AP1000 DOCUMENT NO. APP-GW-GLR-134	REVISION 1	PAGE 1 of 470	ASSIGNED TO W-Sterdis	OPEN ITEMS (Y/N)
----------------------------------------------	----------------------	-------------------------	---------------------------------	------------------

TITLE: AP1000 DCD Impacts to Support COLA Standardization

AP1000 Standard Combined License Technical Report

AP1000 DCD Impacts to Support COLA Standardization

Figure 7.2-1 (Sheet 20 of 20)

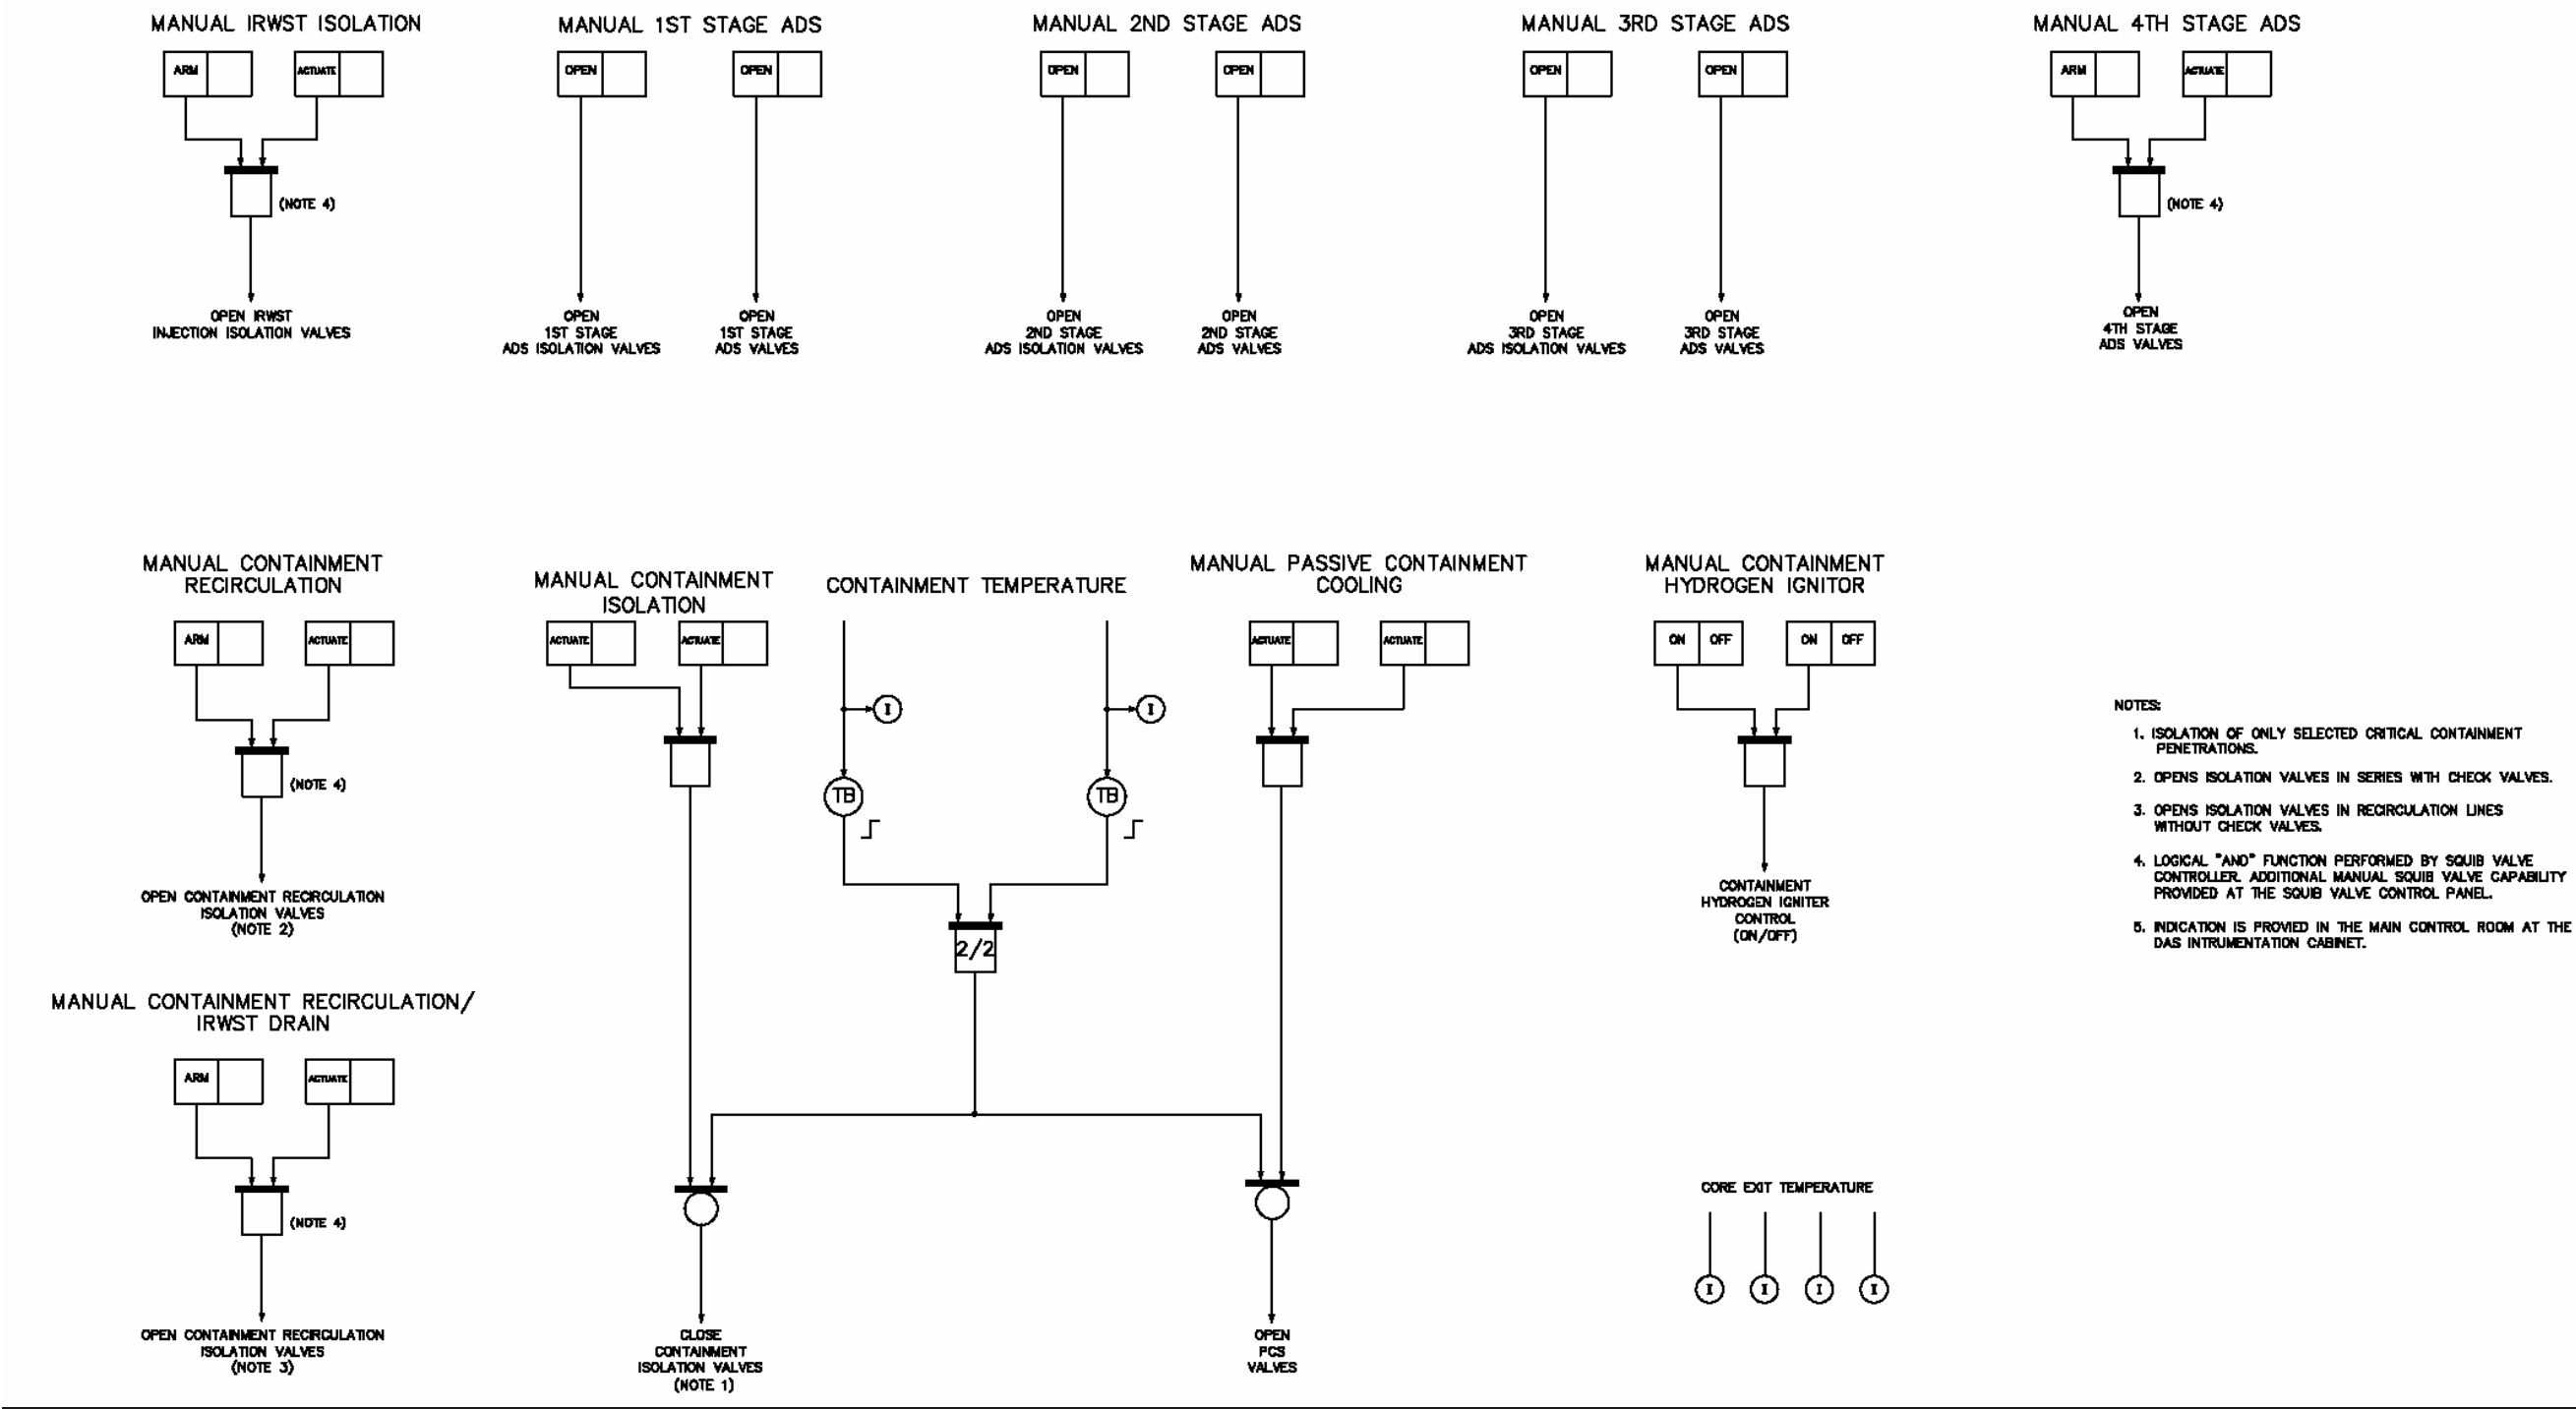
<i>DCD Section</i>	<i>Westinghouse Status</i>	<i>Tracking Number</i>	<i>DCD Category</i>	<i>Change Criteria</i>
7.2, 7.3	Accepted for Revision 17	NRC111	Tier 2	NRC Prior Approval Not Required
<i>Description:</i> NRC 111 contains corrections to Sections 7.2.1.1.1, 7.2.1.1.3, and Table 7.3-1 (sheet 8 of 9), Table 7.3-2 (sheets 1 & 3 of 4), Table 7.3-4 (sheet 2 of 2) to be consistent with APP-GW-GLR-080, Rev.0.				
<i>Reference Information:</i> APP-GW-GLR-080 (TR80), Rev 0

<i>DCD Section</i>	<i>Westinghouse Status</i>	<i>Tracking Number</i>	<i>DCD Category</i>	<i>Change Criteria</i>
7.2-1	Accepted for Revision 17	NRC138	Tier 2	NRC Prior Approval Not Required
<i>Description:</i> NRC 138 has changes to the notes of Figure 7.2-1 (sheet 20 of 20) to be consistent with RAI-TR97-ICE-03.				
<i>Reference Information:</i> RAI-TR97-ICE-03
